The City of Spartanburg Design Review Board

AGENDA

October 7, 2025, at 5:30 P.M.

PROJECT/ADDRESS/ TAX IDSpartanburg Mazda / 500 E Daniel Morgan Ave /
7-12-03-115.00**PROJECT NUMBER**

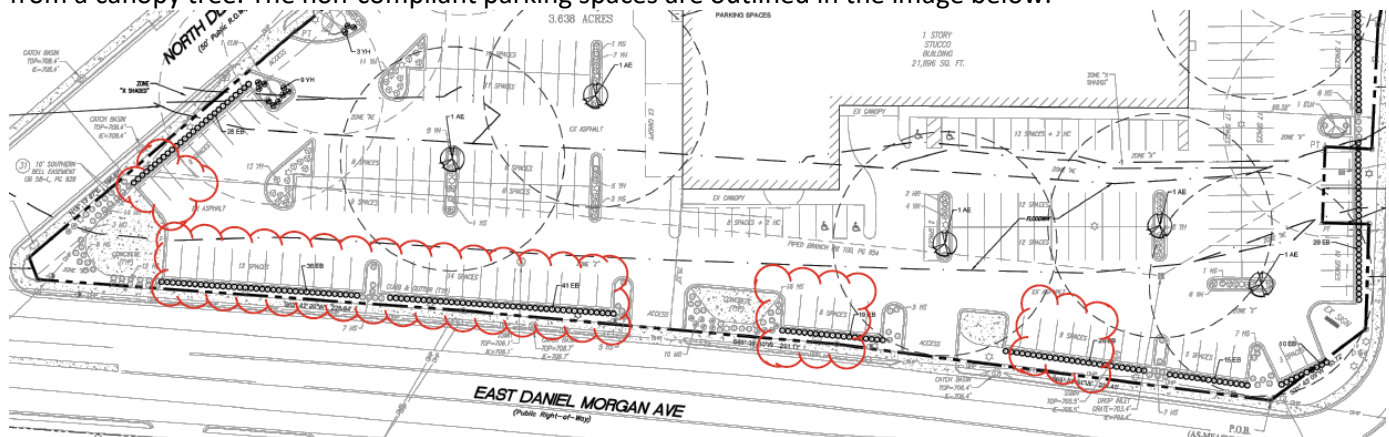
- **8.1 Required Streetscape:**
 - D-T5: 12 ft zone with 8 ft wide sidewalk and trees in wells: *Compliance Required*
- **8.2 Parking Area Landscaping:** *Compliance Required*
- **8.2.1 Required Plantings:**
 - One (10 Shade Tree and Eight (8) Shrubs required per 10 parking spaces: *Compliant*
 - No parking space shall be further than 60 feet from the trunk of a canopy tree: *Not Compliant – 42 parking spaces along E Daniel Morgan Ave outside required range*
- **8.2.2 Parking Area Screening:** *Not Compliant – landscape plan lists shrubs maintained at 2 feet high. Parking areas must have a 3-foot-high screen along the street.*

- I. **Signage:** *Freestanding Sign is non-compliant. Existing pole sign would need to be modified to not exceed 5 feet in height and 32 square feet in area*
